From: Espinales Montoya, Moises <MoisesEspinales@miamibeachfl.gov>
Sent: Monday, April 28, 2025 5:16 PM
To: Joe Vecchione; PERMIT X INC
Cc: Sophia Chesrow; Duncan Bath - Architectural Project Manager Cactus Club
Subject: RE: BC2525225 - 850 Commerce St

Subject: BC2525225 - 850 Commerce St

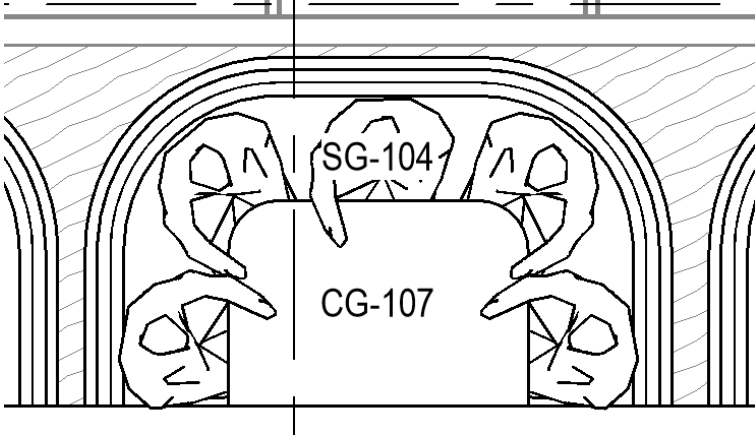
If calculating at 18" per occupant, a booth that realistically can seat 4 patrons is required to seat 8:

Thank you for your patience and for send me the diagrams. I have no objection to the seating adjustments. As a result of this exercised, a CUP will no longer be required. Please update the plans accordingly.

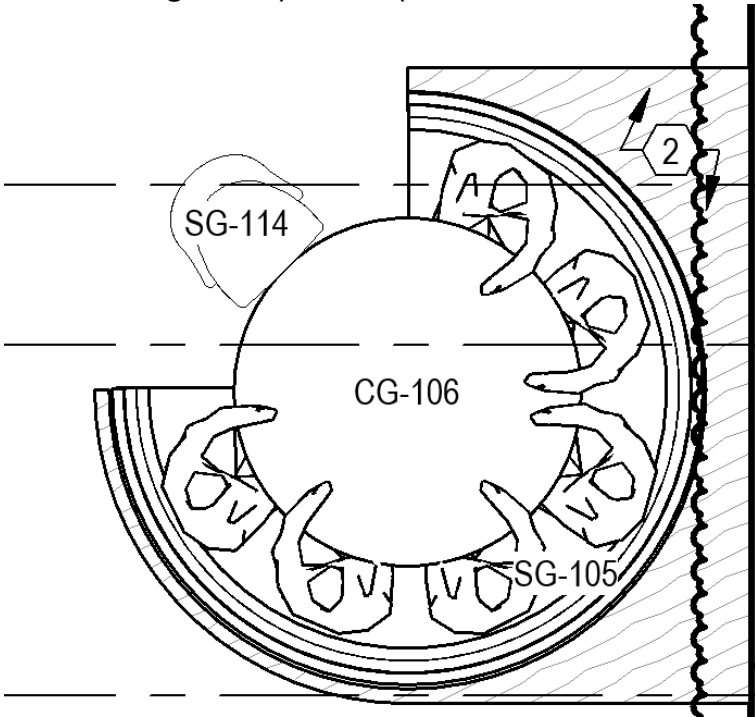
If calculating at 18" per occupant, a booth that realistically can seat 5 patrons is required to seat 9:

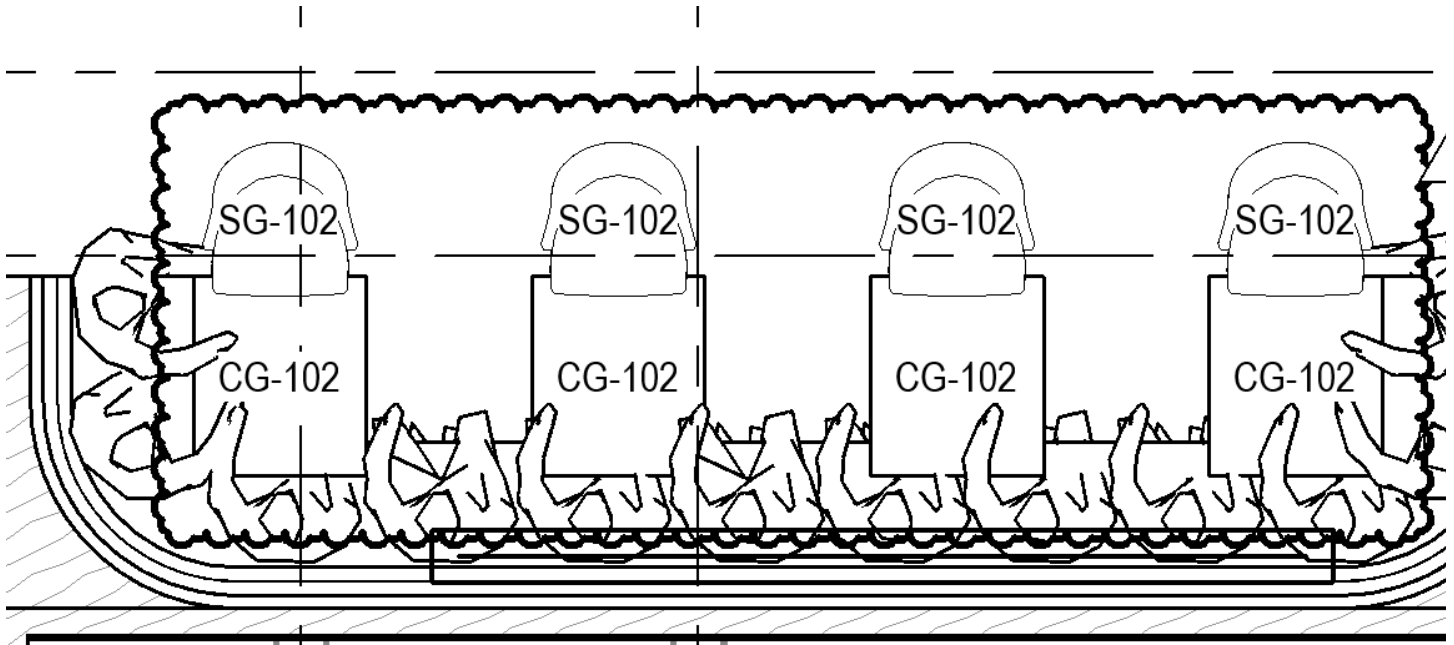
If calculating at 18" per occupant, a booth that realistically can seat 6 patrons is required to seat 11:
